<p align="center">Advisory Action Before the Filing of an Appeal Brief</p>	Application No. 10/780,329	Applicant(s) GRADY, JEFF	
	Examiner Nguyen T. Vo	Art Unit 2618

AUDIO PLAYER ASSEMBLY COMPRISING AN MP3 PLAYER
Applicant: Jeff Grady. Serial No. 10/780,329 Attorney Docket: 4185-101 CIP2
REPLACEMENT SHEET

Figure 1

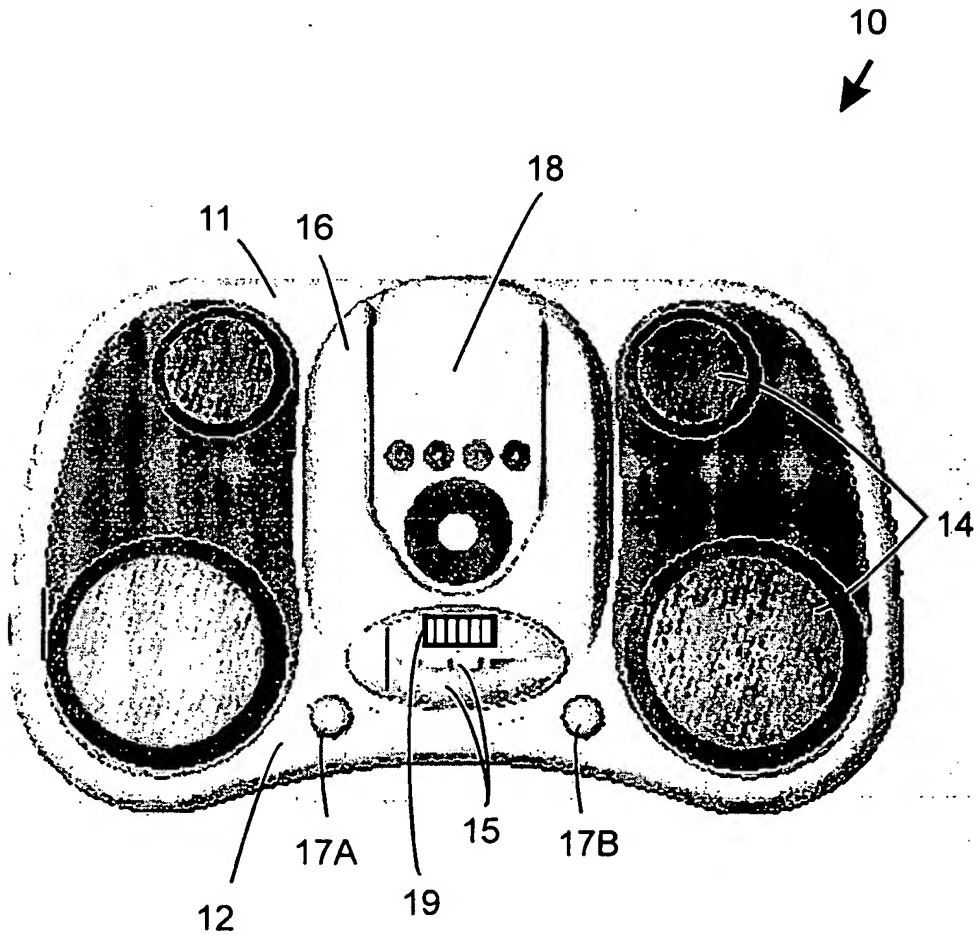
(i) show a frequency indicator or display element 19 located in the modular docking unit which is supported by the original specification (original claim 12).

(ii) merely label the original raised cylindrical knobs as 17A and 17B, which does not raise issue of new matter.

For the above reasons, the examiner agrees with applicant that the amended drawings do not raise issue of new matter. The amended drawing are now acceptable.

The newly-added limitation "Further provided are control elements 17A, 17B, of which one control element may be employed for frequency tuning control" contains new matter. **The original specification does not disclose that one of the raised cylindrical knobs (now labeled 17A and 17B) is for frequency tuning control.** In addition, the original specification discloses that the frequency tuning control element is located in the modular docking unit (see original claim 13). Since the raised cylindrical knobs (now labeled 17A and 17B) are located outside of the modular docking unit (see figure 1), they are clearly not for the frequency tuning control.

*approved
nvs
3/4/2007*
